Our Ref: PL/24/1598
Your Ref:

26 March 2025

RE: PROPOSED FELLING OF ONE OAK AND ONE CHERRY AT 24 RUSSET GLADE - T7 & T8 RESPECTIVELY OF TREE PRESERVATION 20/02 AND PROPOSED 30% REDUCTION OF ONE OAK ON LAND TO THE REAR OF 22 RUSSET GLADE - PART OF W1 OF TREE PRESERVATION ORDER NUMBER 30/02.

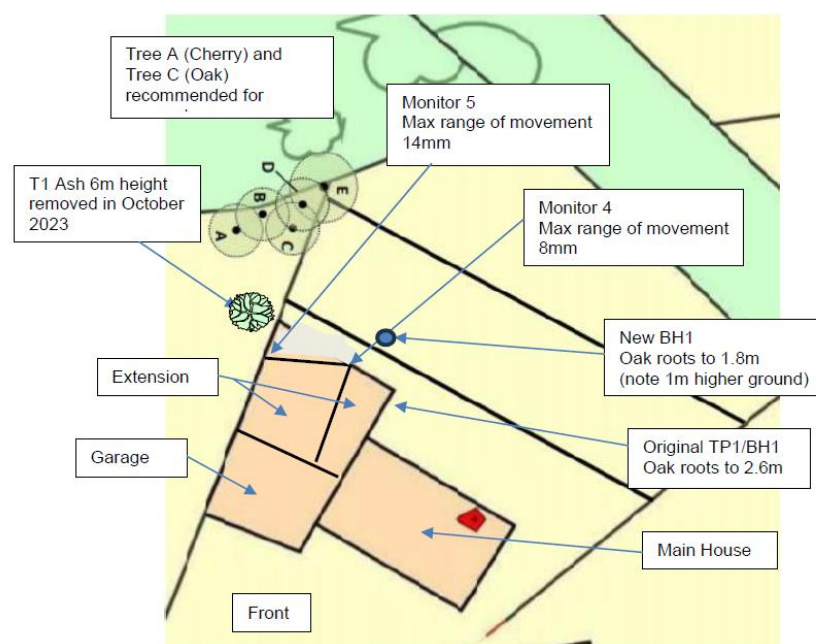
It should be noted that several iterations of the Addendum Arboriculture Report from Crawford & Co have been provided, the final version being provided on 19 March 2025 -

this final version (and others preceding that) did not have revision dates or references hence the date of receipt is the only way to distinguish the final version from others. The original versions included internal and external photographs and crack monitoring results that did not relate to 22 Russet Glade. The final version includes photographs of 22 Russet Glade, albeit these have not been updated since the 2019 report.

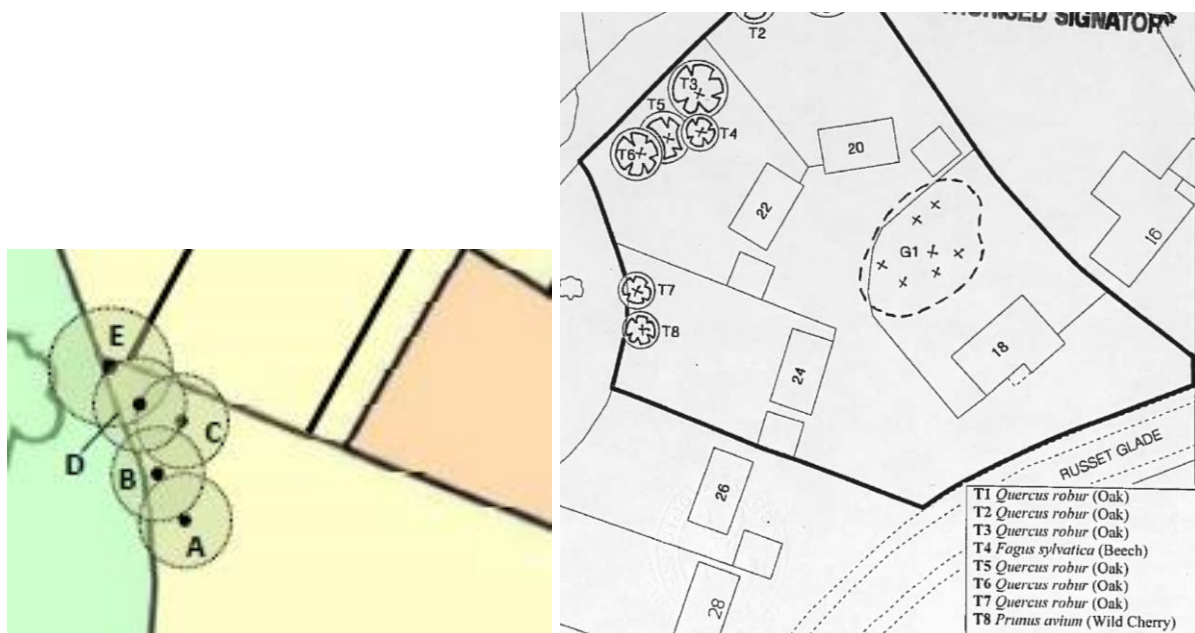
You confirmed that Level Monitoring ceased after the readings taken 13/09/22, that being after the removal of G1 Cypress but before the removal of the 6m high T1 Ash which was located closest to the area with maximum movement. Point 5 located to the rear left-hand corner of the extension showed continual seasonal movement. The range of seasonal movement recorded was a maximum of around 14mm. Point 4 located adjacent to the rear right-hand corner of the extension showed seasonal movement with a maximum range of around 8mm. Seasonal movement continued despite the removal of the TG1 Cypress in January 2020. It would have been beneficial to continue to monitor the property following removal of the T1 Ash tree to assess the influence of T1 on the property.
